12 November 2001

Re: Conditional Tentative Approval of Large Mine Plan Permit Revision, Holnam, Inc., Devil's Slide Quarry, M/029/001, Morgan County, Utah

Ken George
Quarry Coordinator, Holnam Devil's Slide Plant

Appendix A

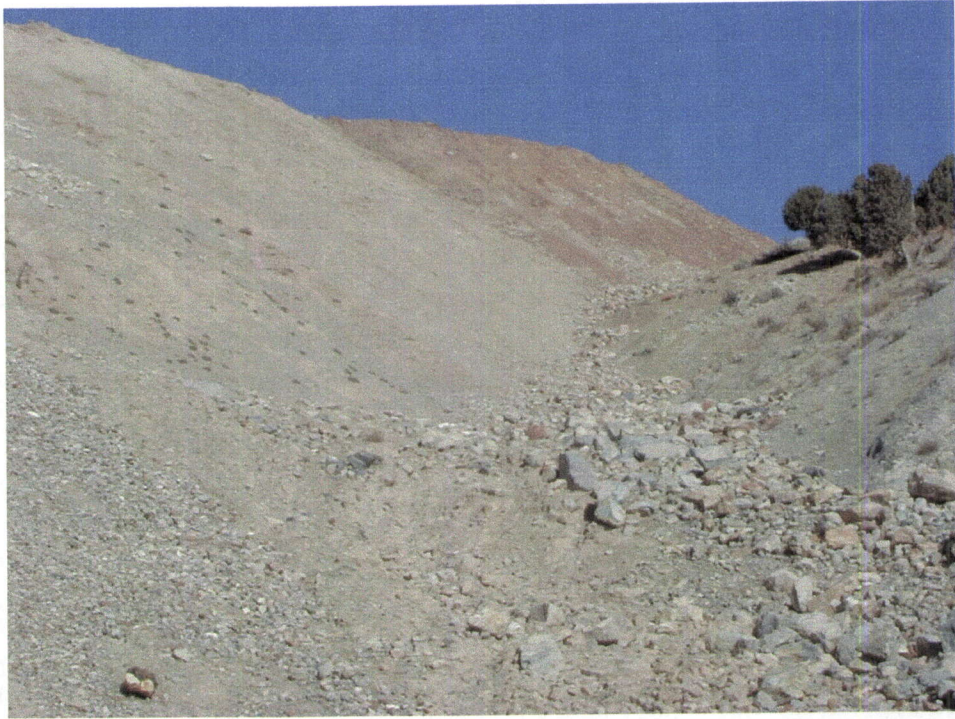
The plan failed to provide a cross section of the 800-foot long culvert, which will be placed in the drainage instead of the 40-inch rip rap channel. A typical cross-section of the proposed culvert installation will be required. Design information related to the culvert is also lacking. Please provide culvert dimension, energy dissipater dimensions, and other appropriate construction details. (TM)

Holnam has decided to not install an 800 foot long culvert in the aforementioned application, in fact, the consultant added that feature to the permit revision without approval of Holnam and it was missed during our review. We intend to install the 40-inch riprap channel instead of the 800-foot long culvert. Attached as an example of the construction of the riprap channel are several photographs (Appendix A) on the existing permitted area where these channels have been constructed using the "French Drain" BMP. These practices have proven to be very successful in other stripping dump and runoff areas on the main mine site and have been implemented on slopes equally as steep as ditch segment 2 (DA-1S (sloped fill), Map R647-4-111.2b).
